ORDINANCE 94-18

TO AMEND THE BLOOMINGTON ZONING MAPS FROM SI to RL, GRANT PUD DESIGNATION, AND APPROVE OUTLINE PLAN
Re: 1730 N. Range Road
(Regency Associates, Petitioner)

BLOOMINGTON PLAN COMMISSION Case No:RL/PUD-15-94
PRELIMINARY STAFF REPORT Date: April-25-94
Location: 1730 N. Range Road, Bloomington, IN 47401

Subj: RL/PUD-15-94 Regency Assocs. 1730 N. Range Rd.

ROAD IMPROVEMENT
RL/PUD-15-94
37

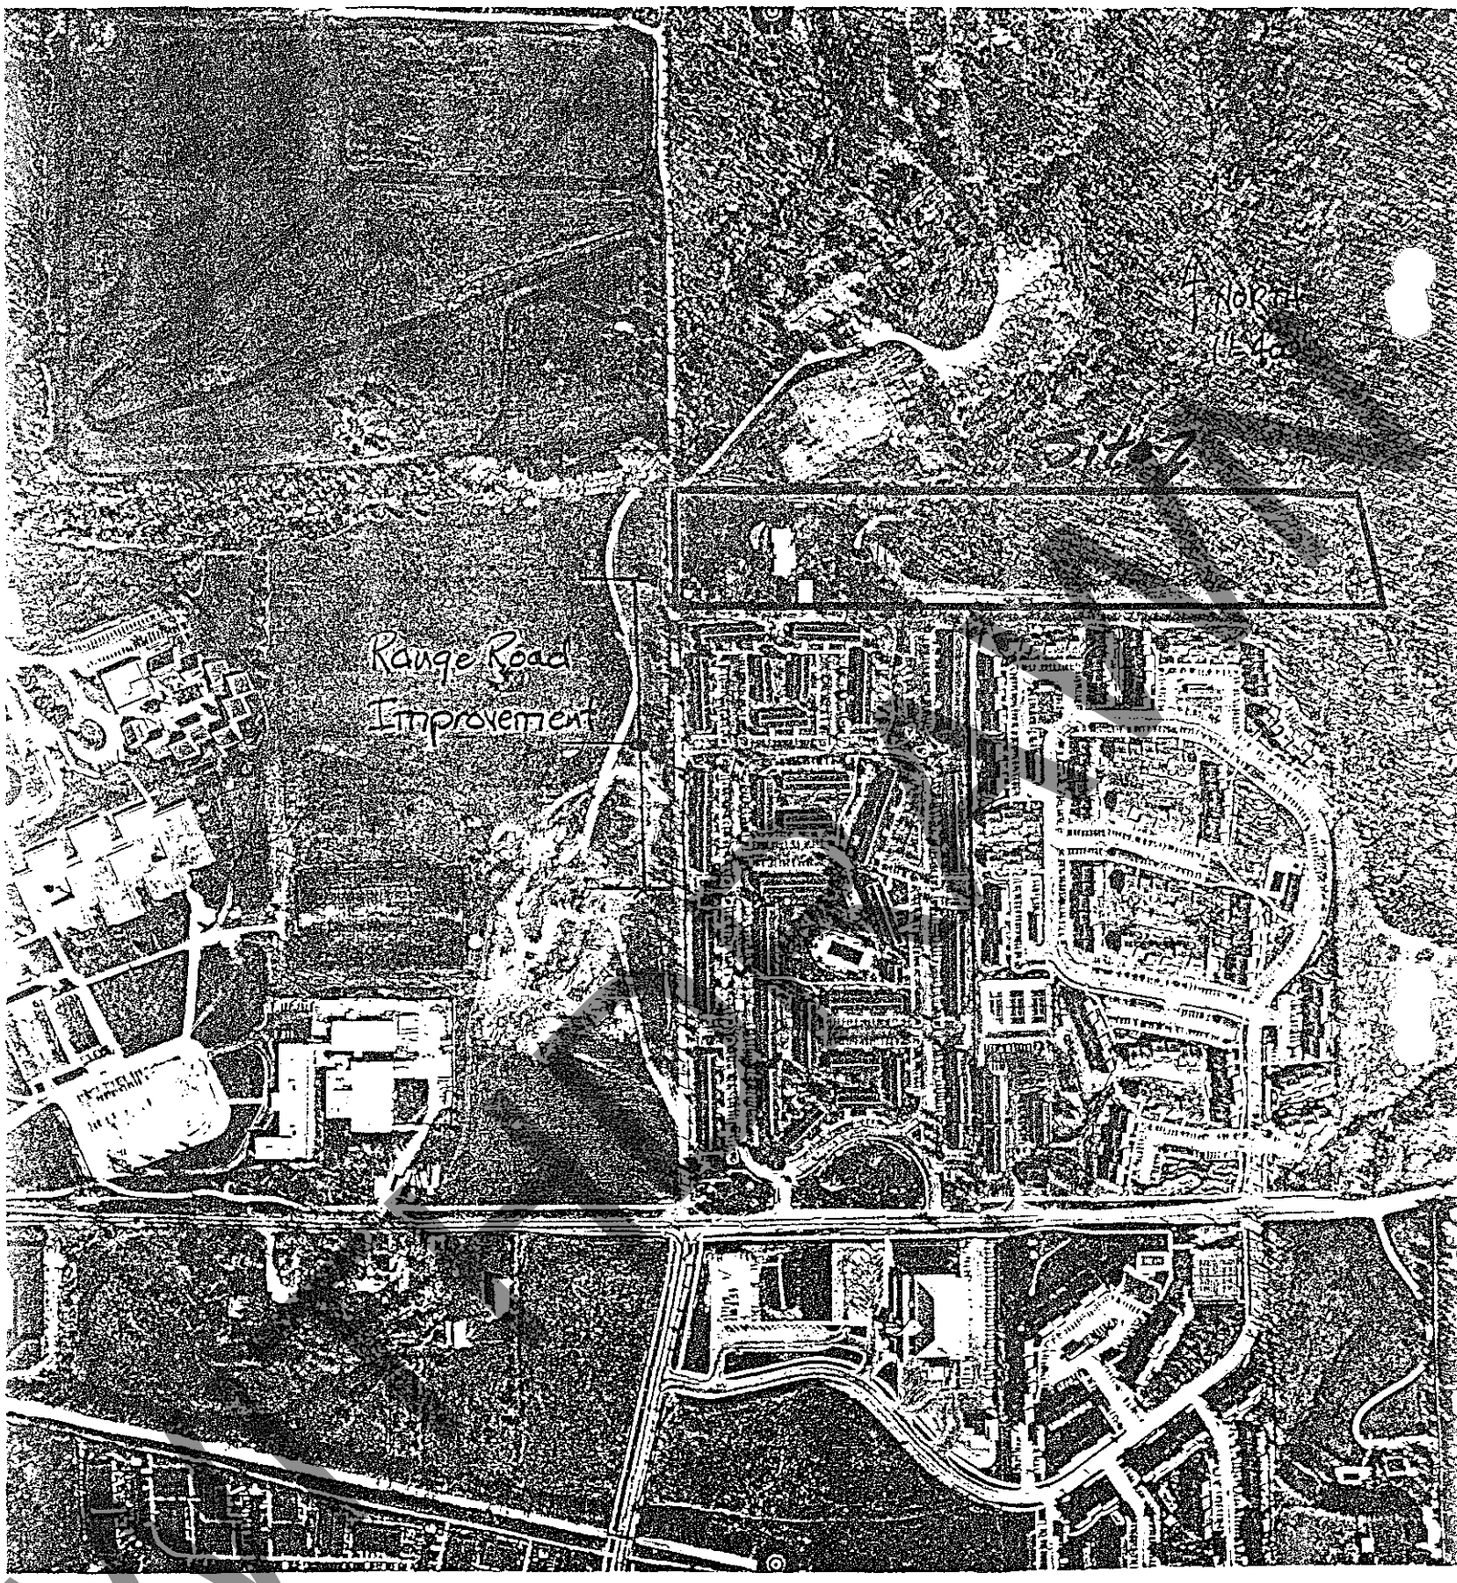
petitioner plans to widen and improve Range north of the access to Indiana University's construction site. Currently the petitioner is proposing a 28' standard as compared with IU's 31' width. Since there will necessarily be tree removal involved, staff will review exact placement of the improvements.

Site Plan
RL/PUD - 15-94

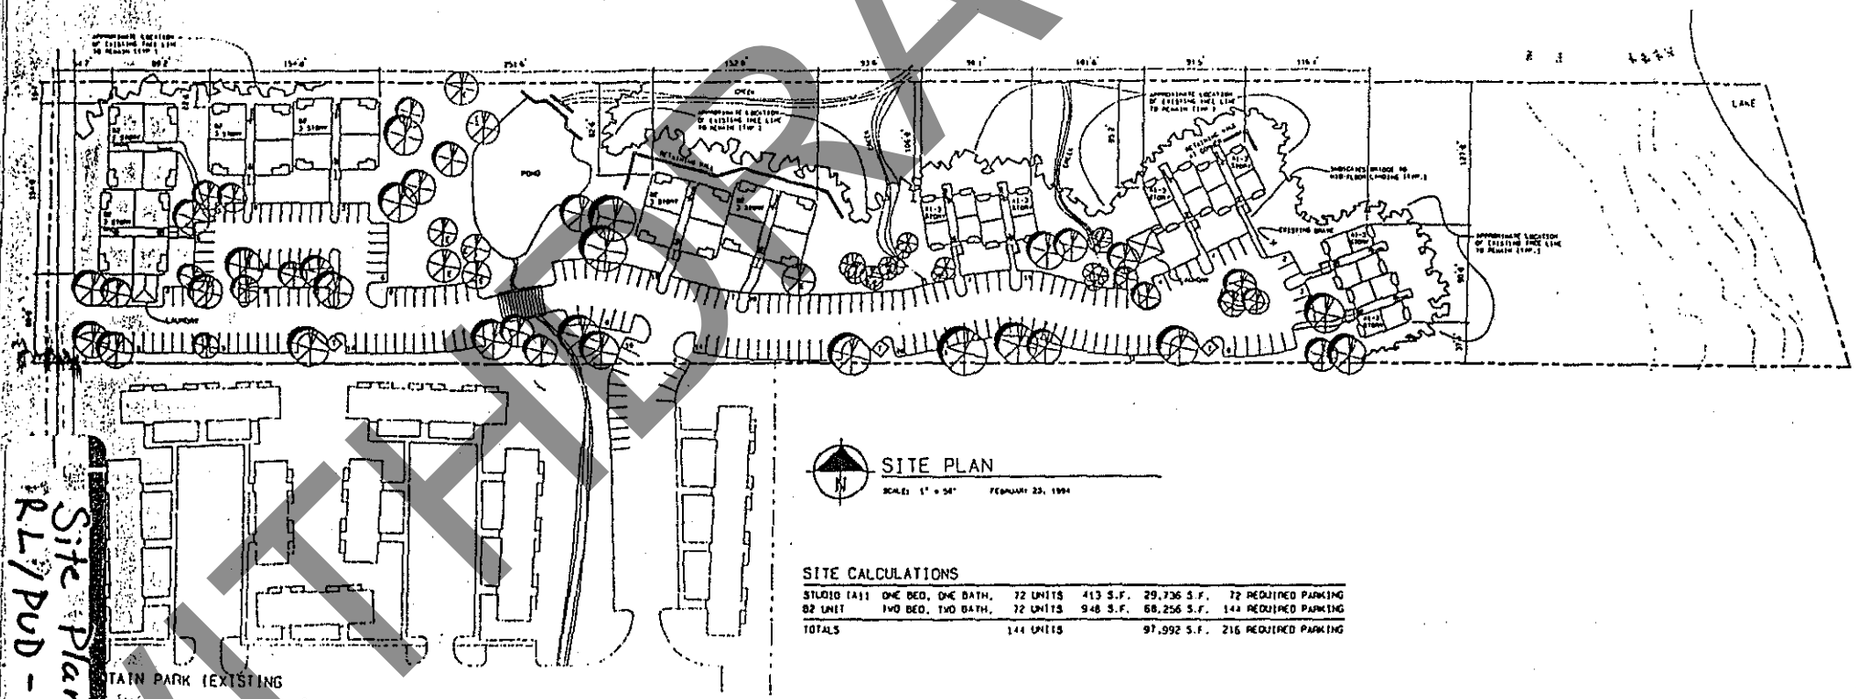
5. The density issue is a difficult one because the high density use to the south conflicts with this property's location in a heavily vegetated site in the Lake Griffy Watershed. The Environmental Commission, however, is advocating the deletion of structure number 3 from the proposed site plan. This would reduce the development's density to 12 units/acre rather than 14.4 but still put it within the Master Plan's range of 12-15 units/acre for high density residential housing. The location of structure number 3 is entirely vegetated and framed by two ravines. The underlying slope is steepest of any of the structures (appoximately 15-16 percent). It requires more parking than the structures located further to the east (48 spaces as opposed to 24). We urge that the Plan Commission consider the positive environmental impacts of reduced impervious area and the maintenance of existing terrain in evaluating the density issue.

3. Aside from sedimentation basins, additional erosion control features need to be incorporated into any development plans. We would expect to see redundant erosion control protection along streambanks and steep slopes. Several of the apartment building footprints (i.e. the building east of the proposed pond and the two eastern apartments) appear to be positioned on slopes close to 15 percent. In order to reduce cut and fill activity, it may not be appropriate to place these buildings on graded pads. The existing slopes should be maintained if possible.

BLDG CROSS SECTION
GRADING PLAN

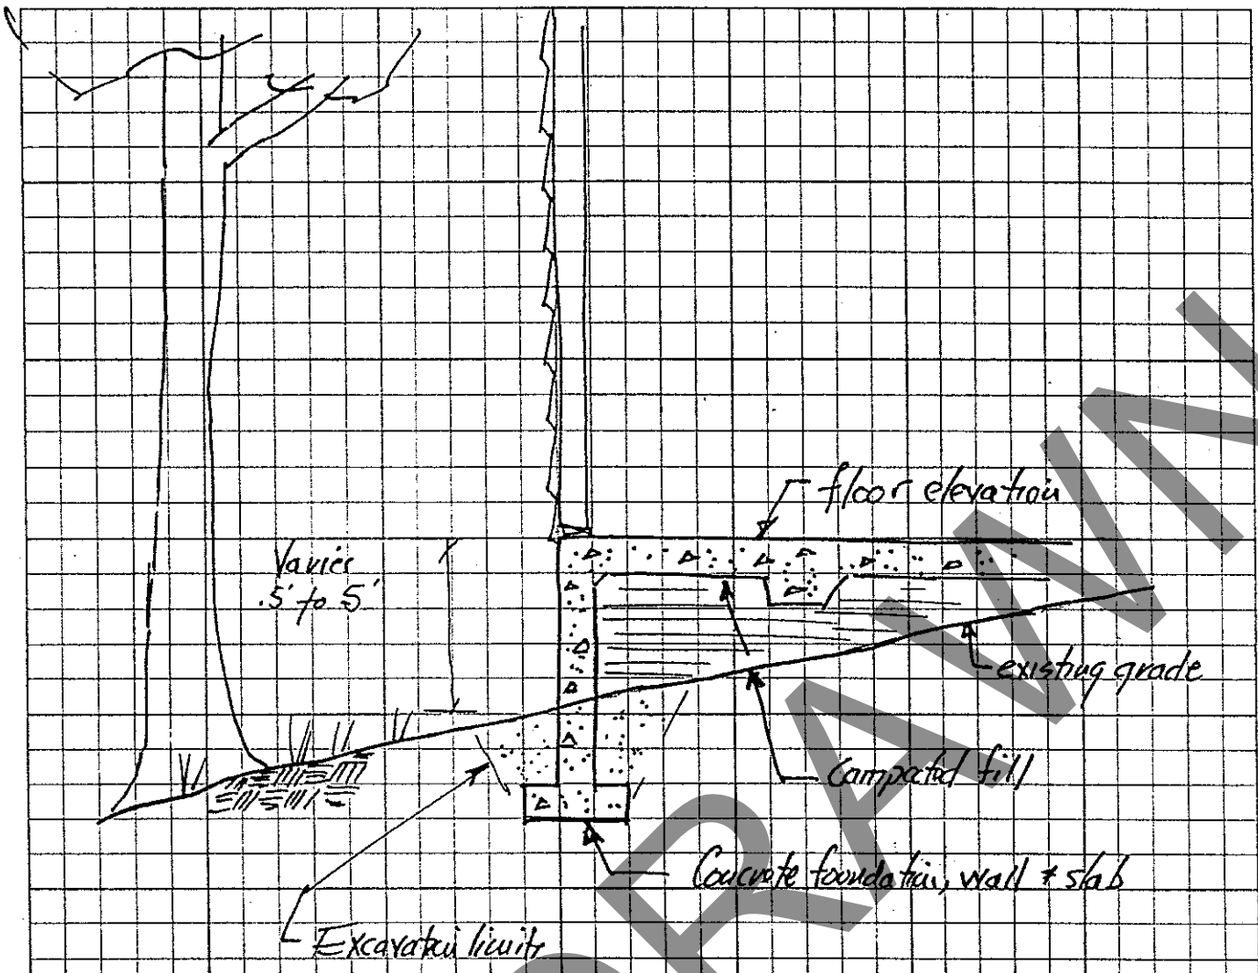
The petitioner proposes to fill and level areas in order to create pads for the apartment foundations. Staff prefers building the footprint into the grade in order to minimize the area of disturbance during construction. The petitioner continues to negotiate with staff concerning this issue and additional information will be presented at the hearing.

A schematic erosion and sediment control plan is being proposed. The most important element of this plan is the configuration of the buildings on the site and on the hillsides. All of the construction is anticipated to be near the top of the hillsides. The buildings are being designed to fit the site. The first floor of the building will be dropped approximately ½ story from the parking lot, a wooden pedestrian bridge will connect the parking lot with the building. This allows the finished floor of the building to be about five feet lower than the parking lot, thereby reducing the amount of earth fill necessary. The building is proposed to be constructed on a slab with fill extending ten feet beyond the back of the building. At that point a loose concrete block retaining wall will be constructed. This wall varies in height from zero to five feet. The limits of construction will be four feet beyond the wall. This construction method minimizes the amount of earth cut and fill and the amount of disturbance on the site.

ILLUSTRATNE POND DETAIL
FOUNTAIN PARK 4/25/94

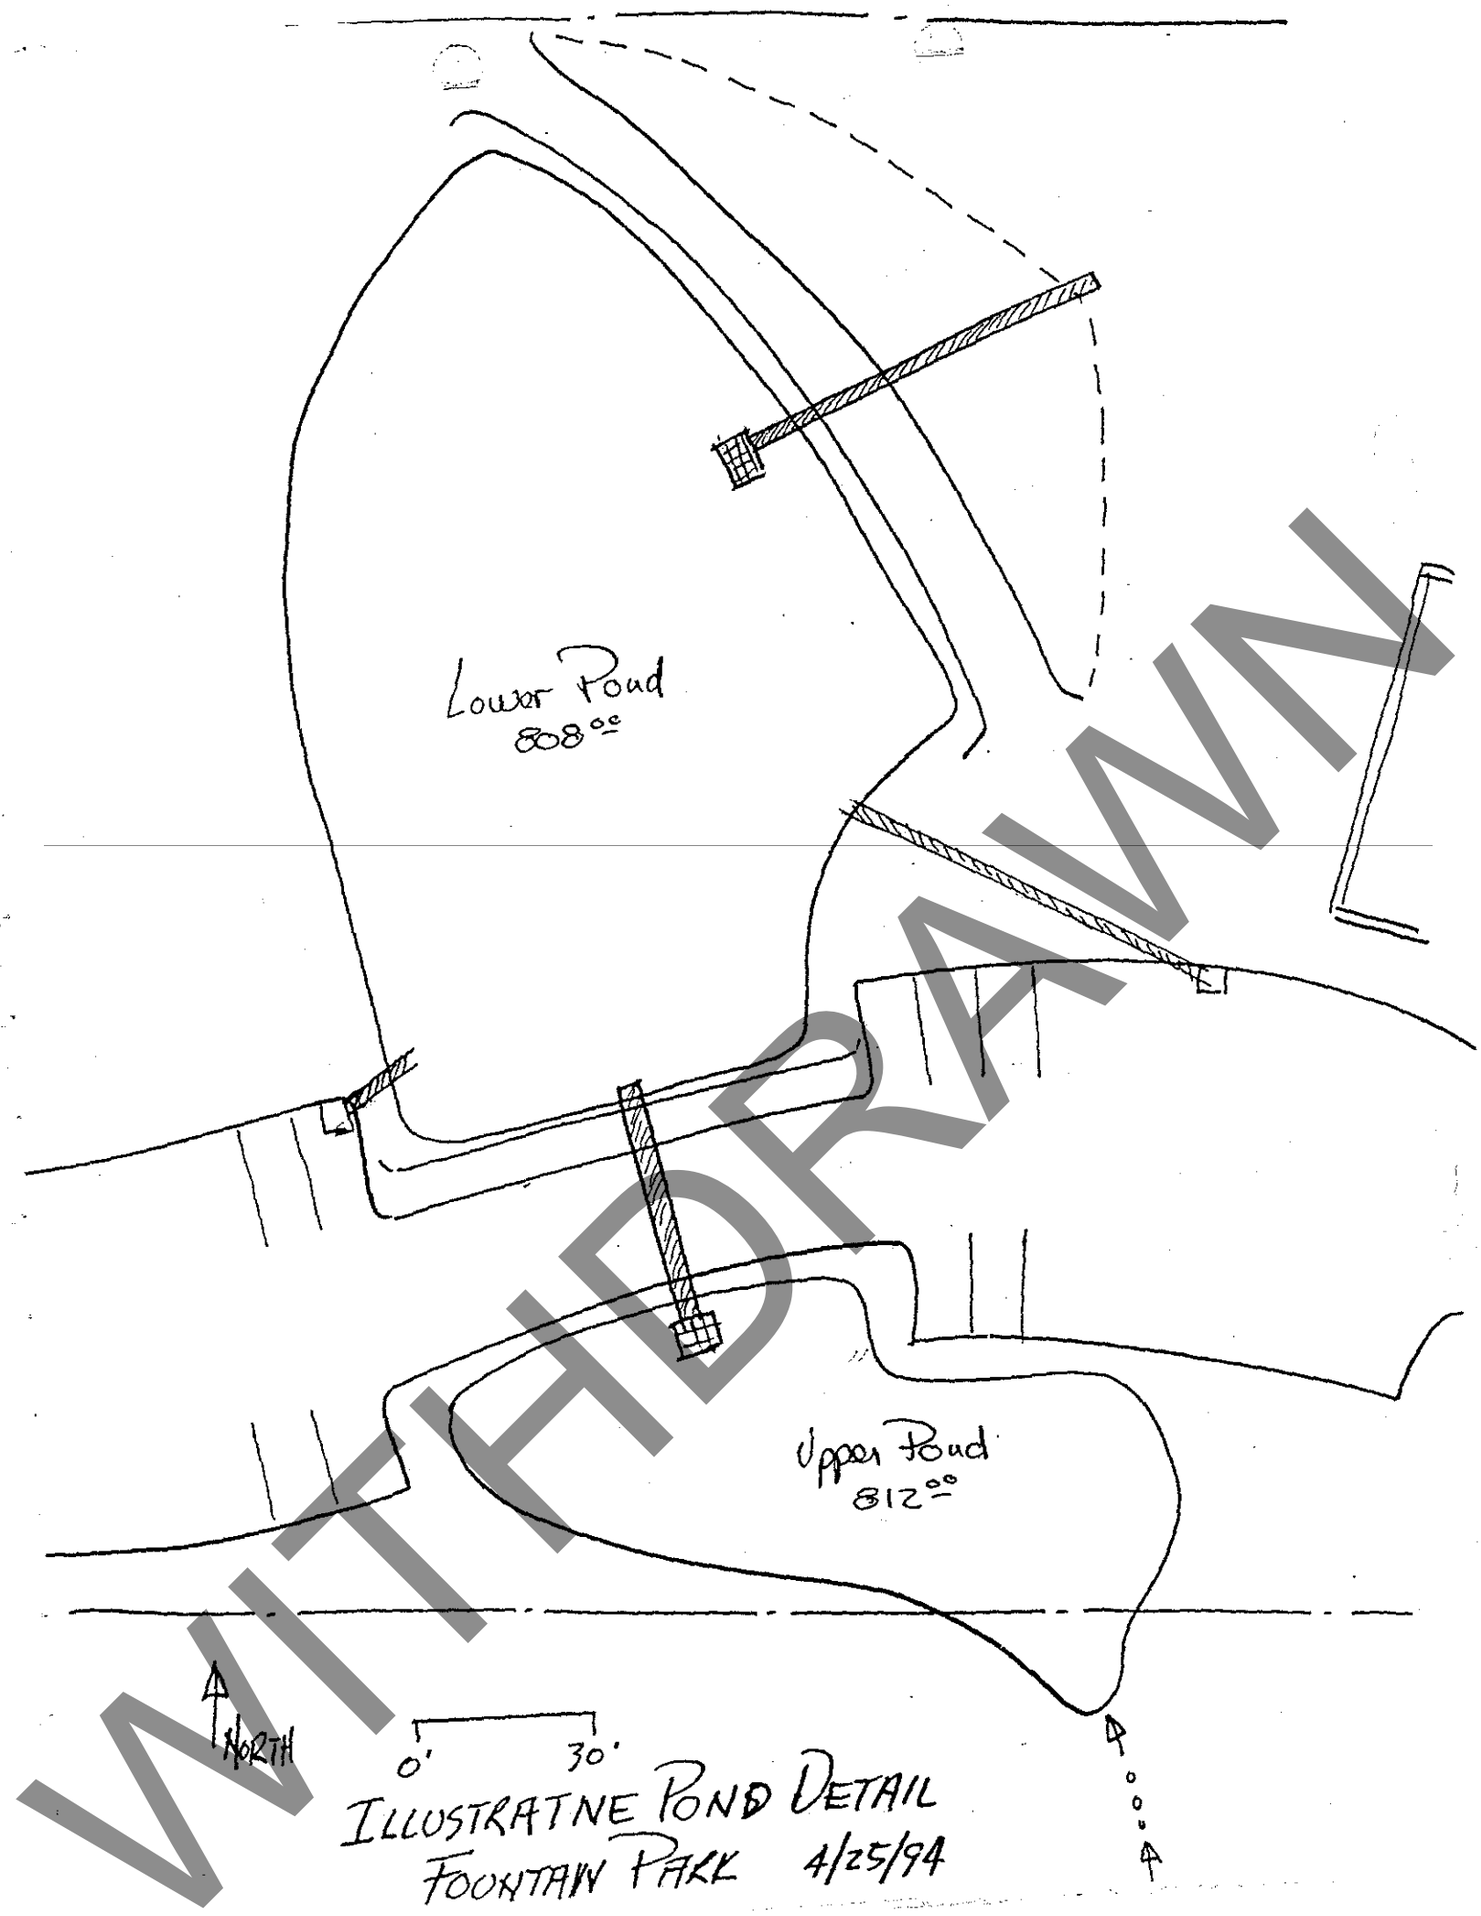
1. The petitioner's stormwater management plan is based around the construction of a permanently wet detention basin on the west-central portion of the site. Although only about 1/3 of the site actually drains into that area at this point, all parking lot drainage will be directed into the basin via a storm sewer pipe. We support this management scheme but are still concerned that no roof drainage or yard drainage will be captured by a basin. Without detention, the only way that this drainage can be slowed and absorbed is by using grass swales which could incorporate vegetative filters. We urge the petitioner to consider some stormwater control for this additional drainage even though it is not as critical as the parking lot drainage.

2. We are pleased at the petitioner's proposal that the detention pond be partially vegetated to provide greater filtration of stormwater pollutants. The petitioner has indicated a willingness to establish approximately 50 percent vegetation cover in the pond and work with wetlands vegetation specialists to select appropriate pond vegetation. The Environmental Commission expects to see these pond design issues resolved by development plan stage. We also recommend that a pond maintenance program be worked out at this stage. Included in this maintenance program should be specific information about inspections and financial responsibility for pond upkeep.

SEDIMENT CONTROL POND

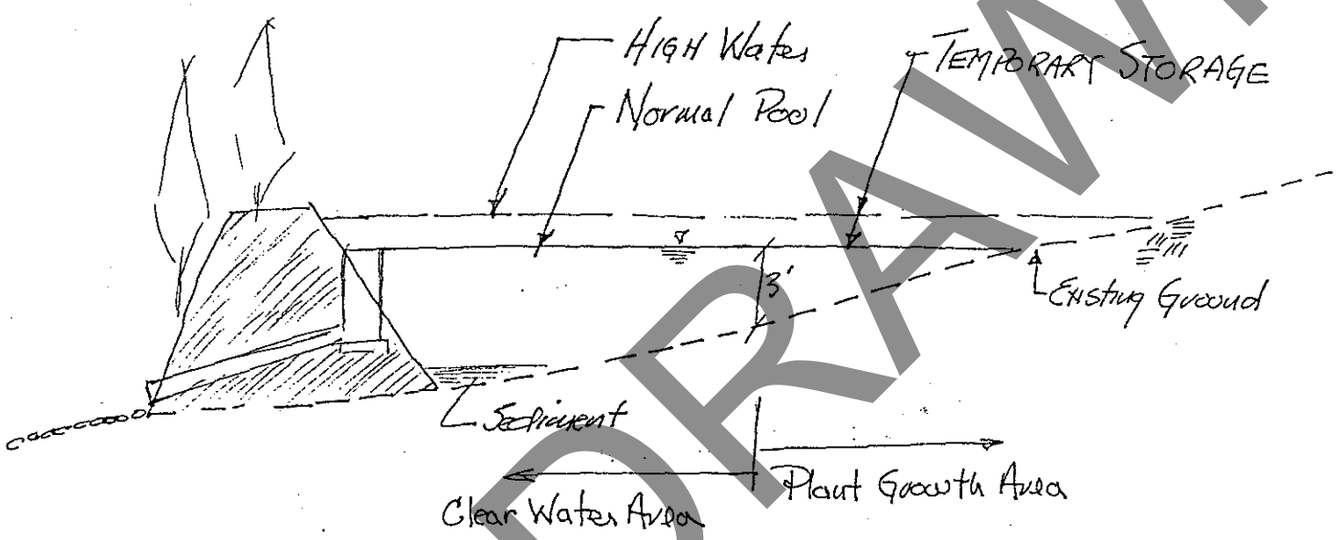
The petitioner has included a cross section of the sediment control pond which would be vegetated from a depth of 3' to the perimeter of the pond. This pond would retain sediment from both the parking areas in the existing Fountain Park site and the new ten acre development. The design would channel run-off via a storm sewer system to a single detention area. The detention area will feature vegetative filters.
